From: Taylor Elm - DNR <taylor.elm@state.co.us>
Sent: Thursday, August 25, 2022 2:44 PM
To: Katie Taylor
Cc: Dave Kubeczko - DNR; Miracle Pfister; Steve Seidel; Clint Beck; Rebecca Deal; Danielle Neumann - DNR
Subject: Re: Anschutz Exploration Corporation: Request for Waiver to Rule 1202.c.(1)S. and 1202.a.(3) for
Attachments: Anschutz_Coyote 0397-14_Request for Waiver to 1202.c.(1)S. & 1202.a.(3)_2022.08.23.pdf

Re: Anschutz Exploration Corporation: Request for Waiver to Rule 1202.c.(1)S. and 1202.a.(3) for Coyote Fed 0397-14 Proposed Location

Map 1. Coyote Fed 0397-14 Pad Water Resources Map

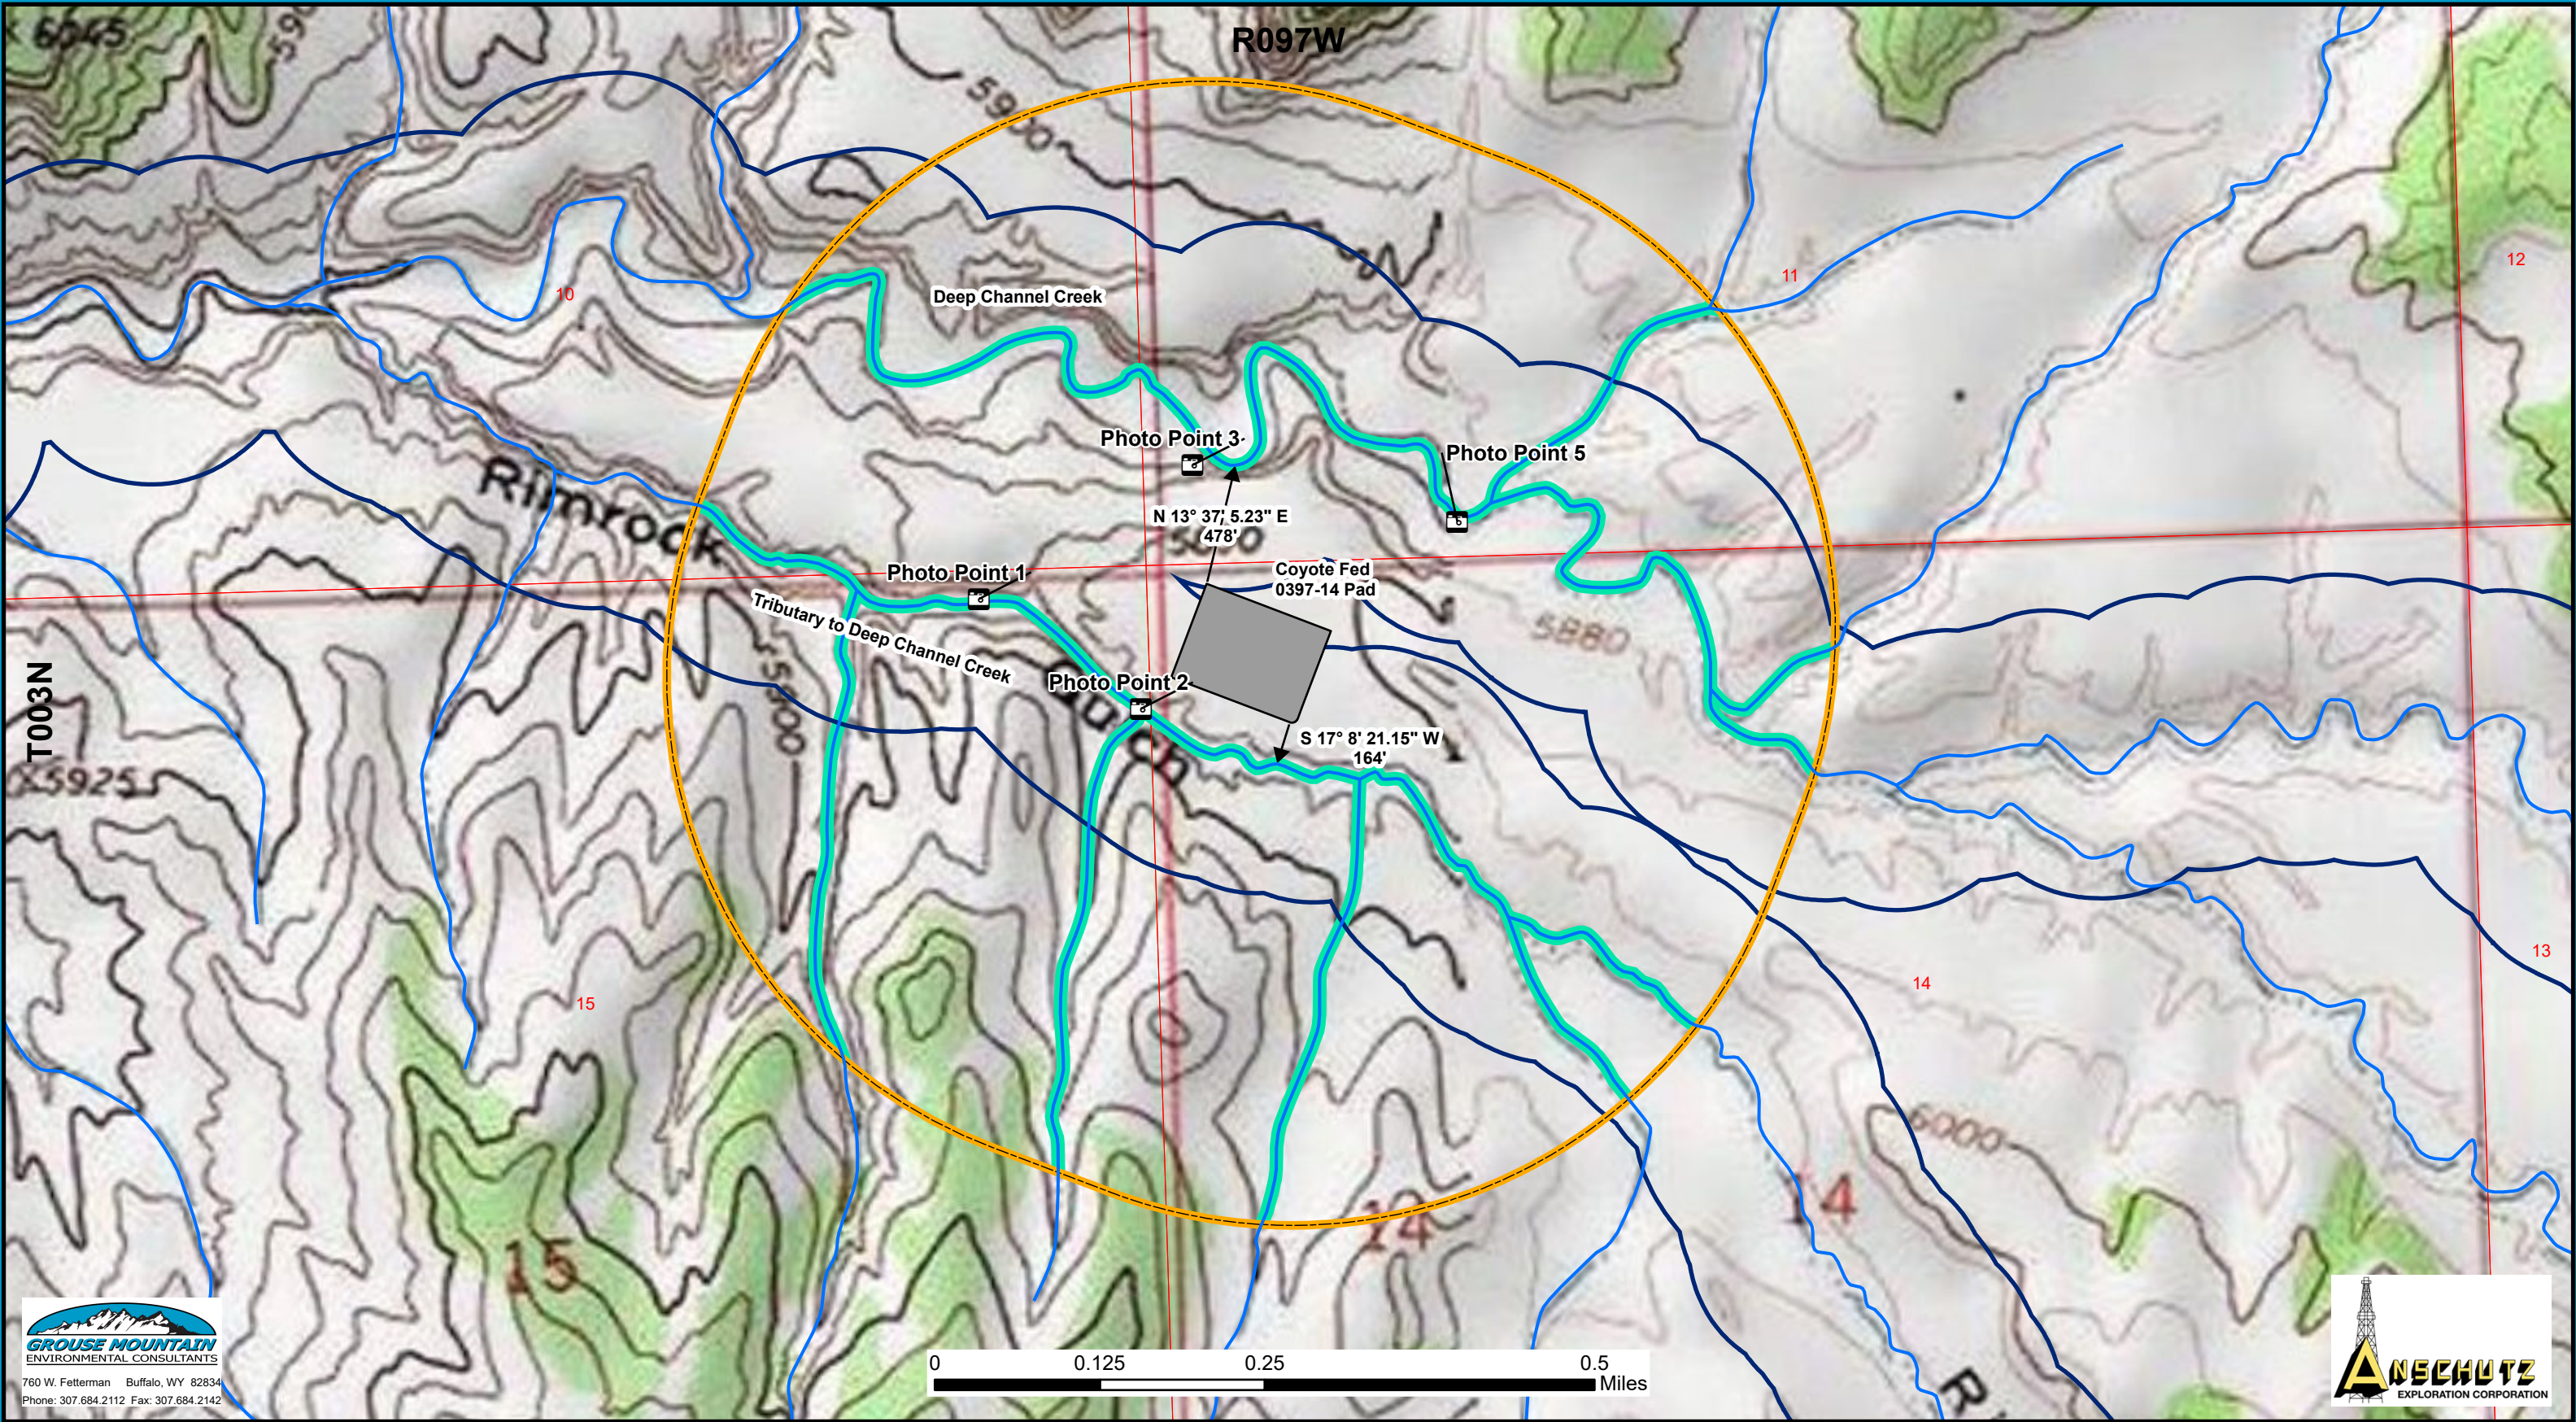
CPW staff, including local aquatic biologists, agree with your assessment regarding the intermittent nature of these two drainages. Based on NHD mapping and our on-site assessment, the unnamed tributary to Deep Channel Creek appears to rarely convey water and most likely only during extreme storm events. Furthermore, Deep Channel Creek may convey water on a more frequent basis, but does not contain year-round flows that would be required to support a sport fishery. In addition to the intermittent nature of these waterways, the nearest downgradient perennial waterway that contains fish populations is significantly downstream of the proposed pad location (i.e. approximately 12 stream miles). Native fish species (Bluehead Suckers, Flannel-mouth Suckers, Roundtail Chub, etc.) that reside in the White River are not likely to use the upper reaches of Deep Channel Creek, and CPW does not have concerns other than the sportfish management waters designation.

Wash Creek and White River. Please see the attached Hydrology map for distances to streams and Sportfish Management Waters (Appendix A).
